Subject: Trail Mtn R2P2 for New Tract

3482
U-082996
U-64375
(U-065c)

BEAVER CREEK COAL COMPANY
 9, TRAIL MOUNTAIN COAL MINE
 PROJECTED MINE PLAN, 9/10/90

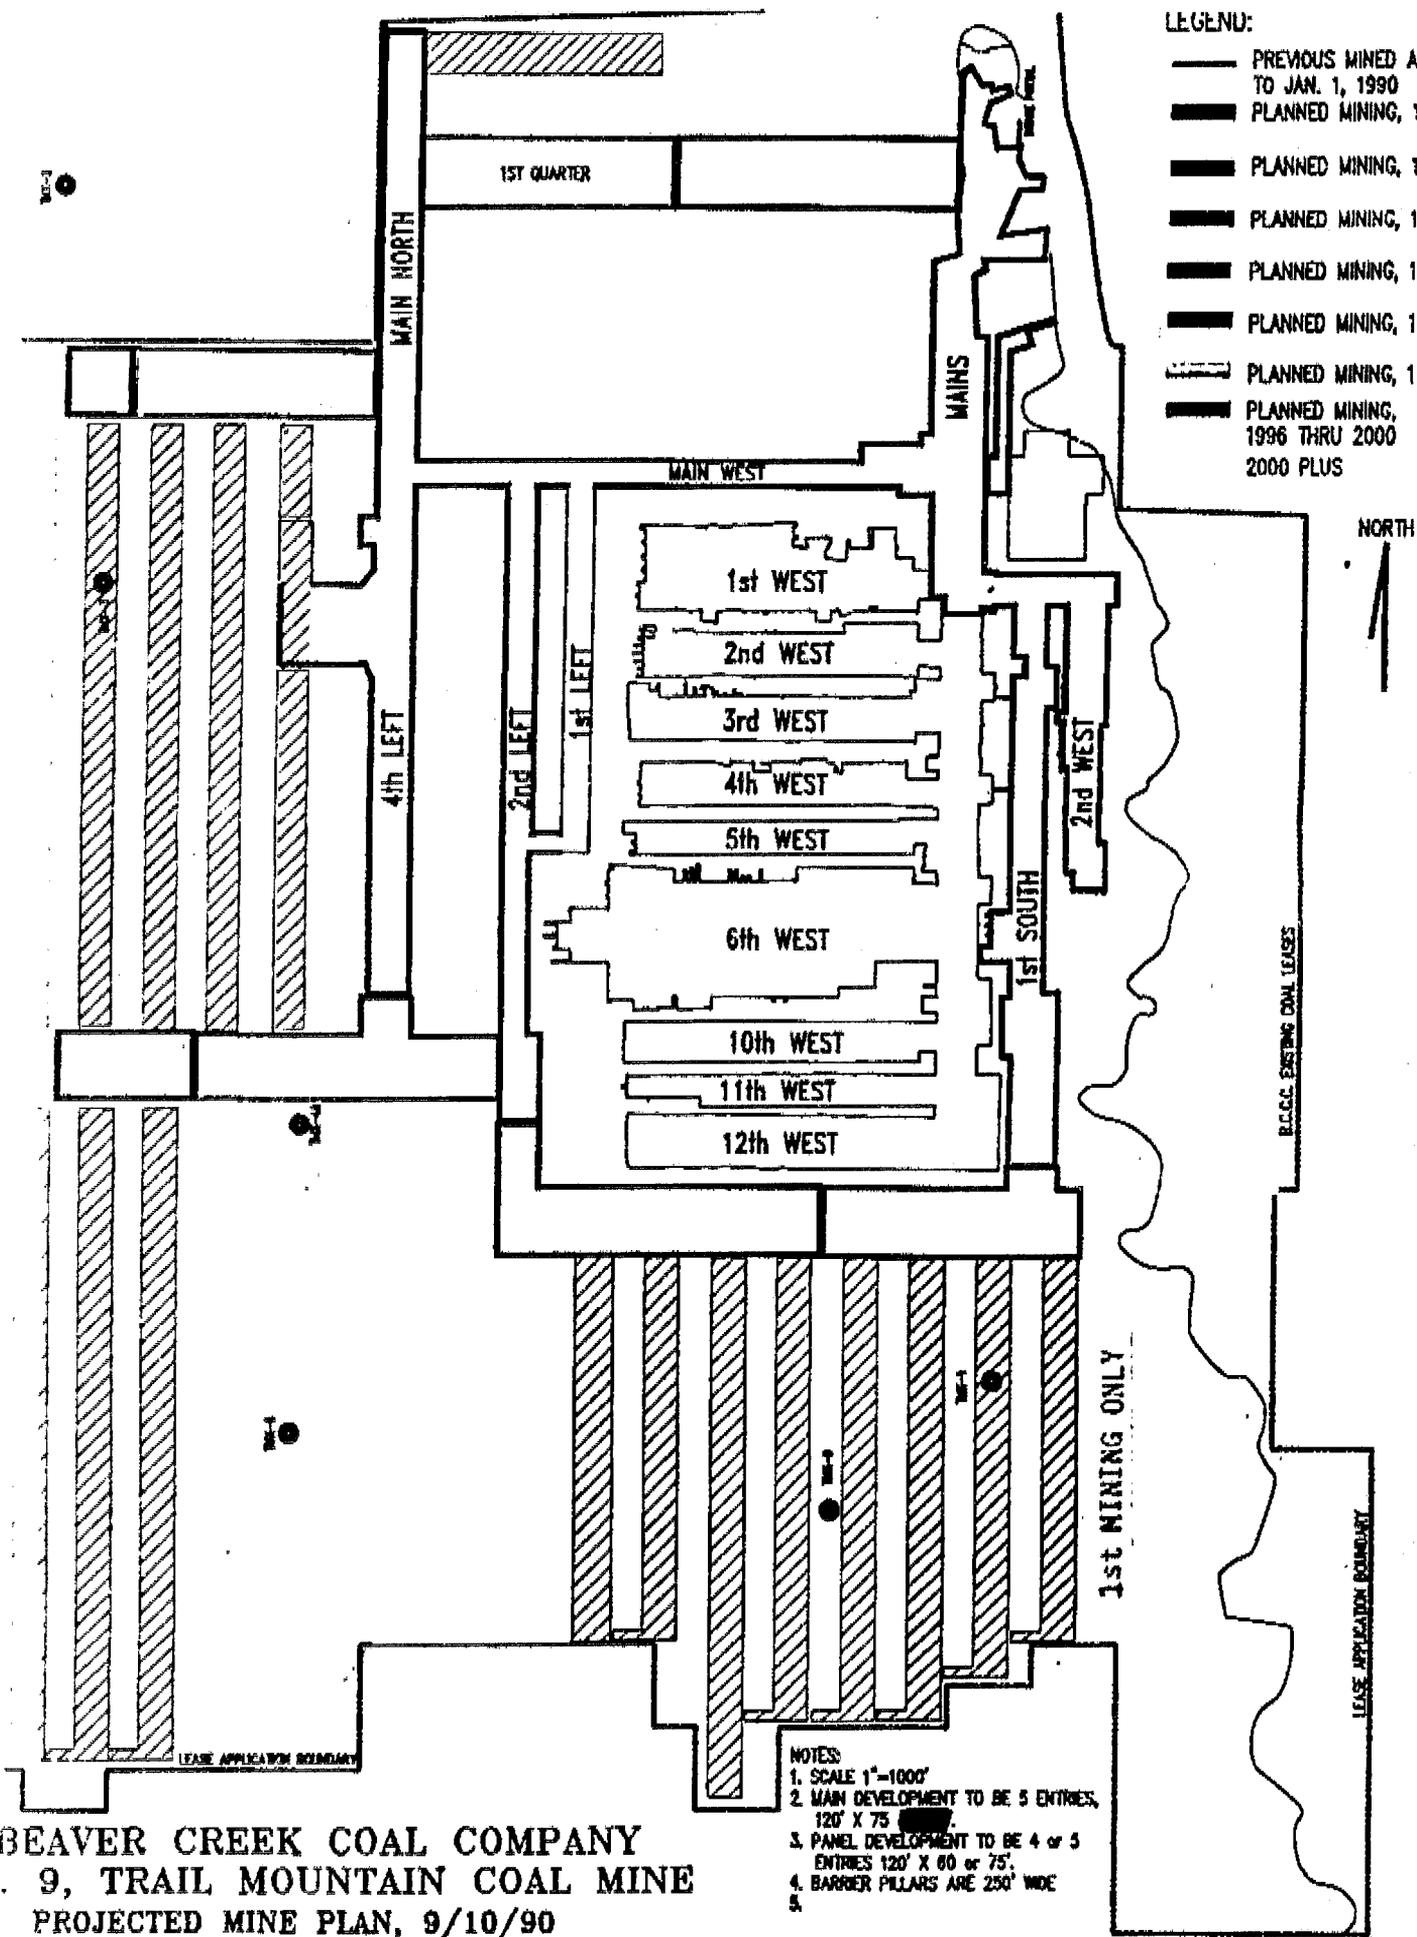
Lease terms specify protection of cliffs from mine-induced subsidence failure. In reviewing the plan, one planned room and pillar panel falls under the area of influence of potential escarpment failure due to subsidence caused by mining activities. To avoid potential escarpment failure, the last panel on the eastern boundary of T18S, R6E, section 1, will be limited to first mining only in order to leave pillars of sufficient size to prevent caving of the strata (see attached map). With this addition, the plan is adequate and technically complete.
